SPADRA BASIN GROUNDWATER SUSTAINABILITY AGENCY

Groundwater Sustainability Plan Advisory Committee Meeting

3. Public Comment
4. Approval of Minutes for Meeting held on November 19, 2019
5. Review of Revised Draft Technical Memorandum 1: *Conceptual Model of the Spadra Basin*
6. Approval of 2020 Advisory Committee Meeting Dates
7. Discussion on Request for a Tour of the Pomona Wastewater Treatment Plant
8. Adjournment to Next Meeting on Monday, April 6, 2020

On November 19, 2019, a draft of “TM 1 – Conceptual Model of the Spadra Basin”, was presented and discussed at the Spadra Basin GSA Advisory Committee meeting. In addition, a draft of TM 1 was made available on the Spadra Website and an email was sent to all interested stakeholders inviting them to review the draft and to provide any comments. The only formal comments received were from the State of California Department of Fish and Wildlife (CDFW). Attached is a redlined version of TM1, which includes edits per CDFW comments. The comments received along with our responses has been formally incorporated into TM 1 as Appendix A.

Shallowest Depth to Groundwater
Fall 2008
Figure 2-29

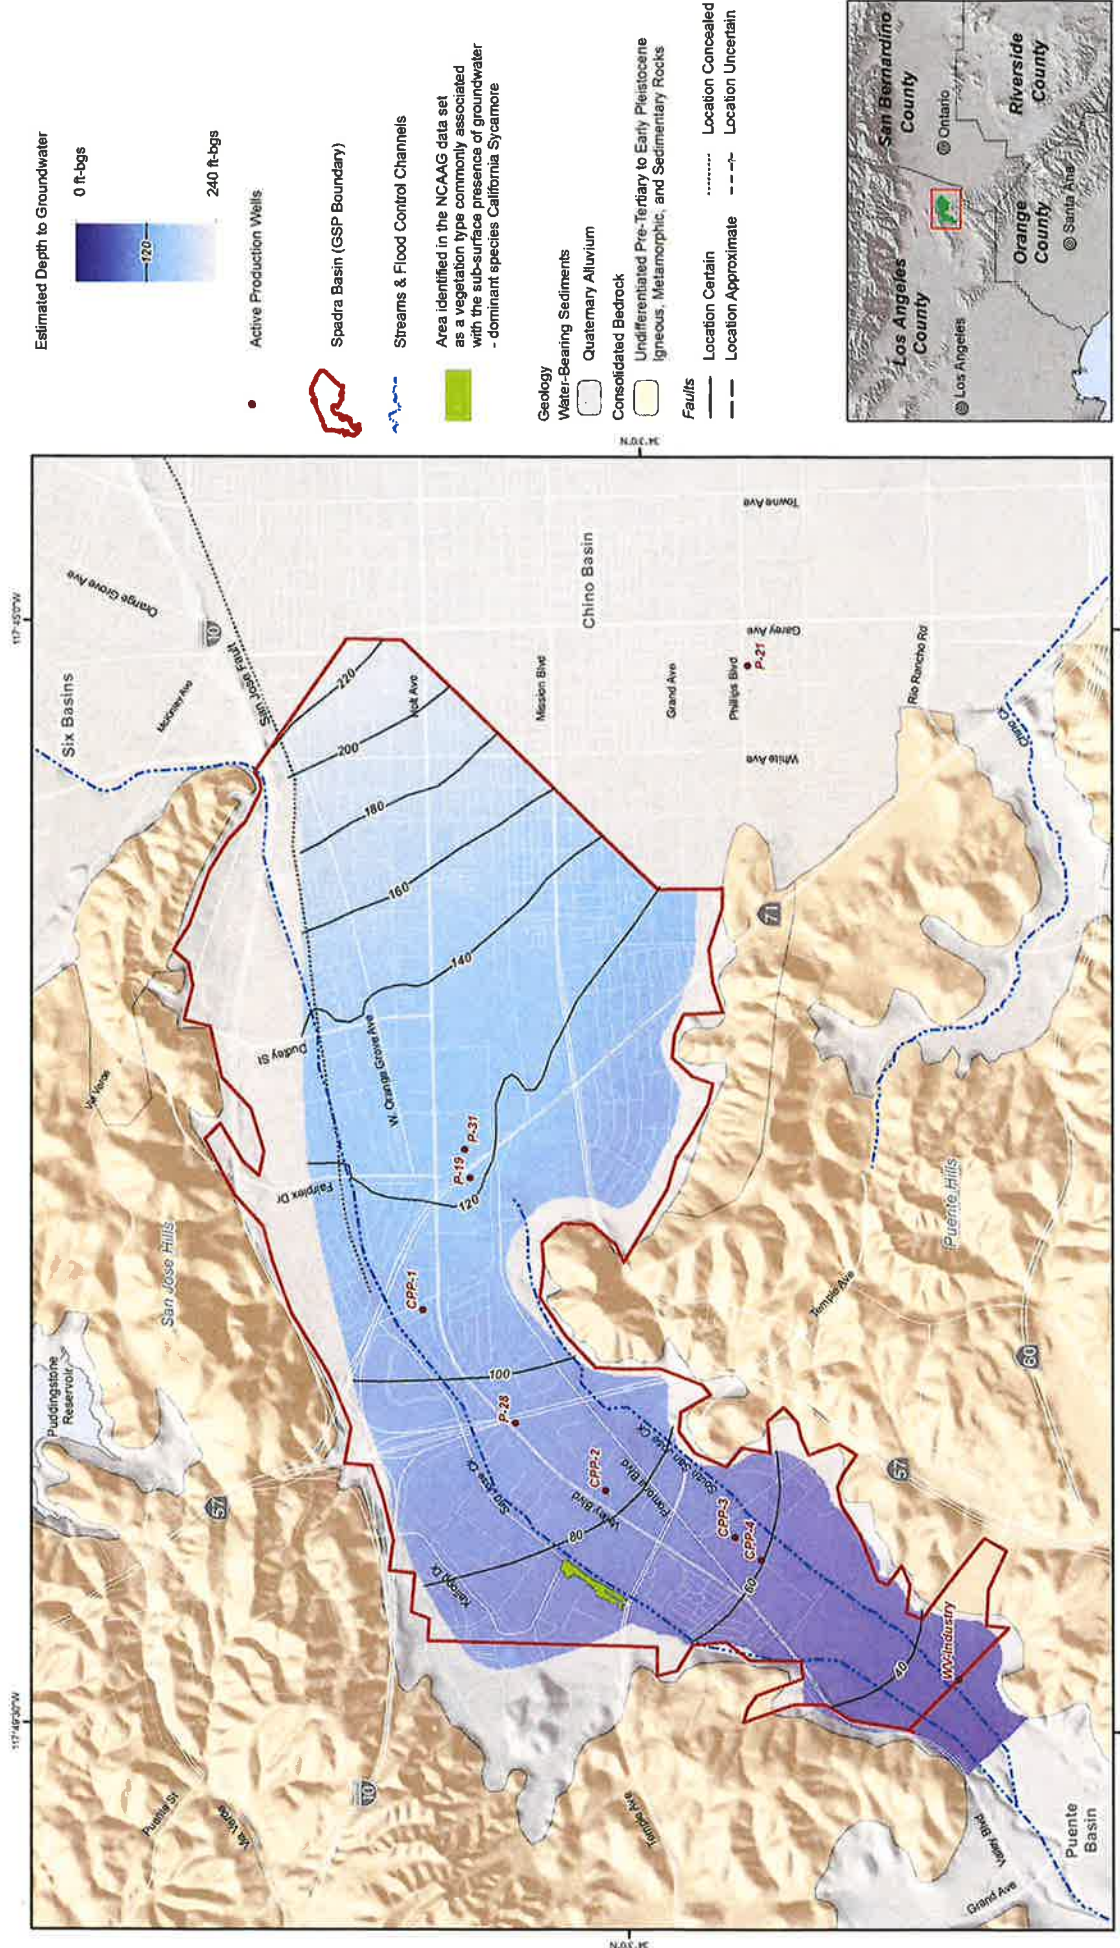
“The GSP Regulations require that GSPs identify groundwater dependent ecosystems (GDEs), and where appropriate, consider the potential impacts on GDEs. GDEs are defined in the GSP Regulations as “ecological communities of species that depend on groundwater emerging from aquifers or on groundwater occurring near the ground surface.” Figure 2-29 is a map of depth-to-groundwater in the Spadra Basin in 2008, a period of highest recorded groundwater levels. Depth-to-groundwater in 2008 ranged from a maximum of about 220 ft-bgs in the eastern portion of the Spadra Basin to a minimum of about 40 ft-bgs at the western margin of the basin. Maximum rooting depths for vegetation in GDEs is typically less than 30 ft-bgs. Because depth-to-groundwater is greater than 40 ft-bgs, and because all stream channels in Spadra Basin are concrete-lined, there appears to be no areas of interconnected groundwater and surface-water or shallow groundwater in the Spadra Basin that are supporting GDEs in the Spadra Basin.

On the DWR’s Natural Communities Commonly Associated with Groundwater (NCCAG) dataset map viewer of GDEs¹ there is one small area mapped as a vegetation type commonly associated with the sub-surface presence of groundwater (mapped vegetated area). The mapped vegetated area is shown on Figure 2-29 and includes the dominant species California Sycamore (*Platanus racemose*). The NCCAG data set is to be used as a starting point to identify GDEs with a groundwater basin and should be researched and verified using local knowledge.

Response. Figure 2-29 is a map of depth-to-groundwater in the Spadra Basin in 2008, a period of highest recorded groundwater levels. Depth-to-groundwater in 2008 ranged from a maximum of about 220 ft-bgs in the eastern portion of the Spadra Basin to a minimum of about 40 ft-bgs at the western margin of the basin. Maximum rooting depths for vegetation in GDEs is typically less than 30 ft-bgs. Because depth-to-groundwater is greater than 40 ft-bgs, and because all stream channels in Spadra Basin are concrete-lined, there appears to be no areas of interconnected groundwater and surface-water or shallow groundwater in the Spadra Basin that are supporting GDEs or other environmental beneficial uses in the Spadra Basin.
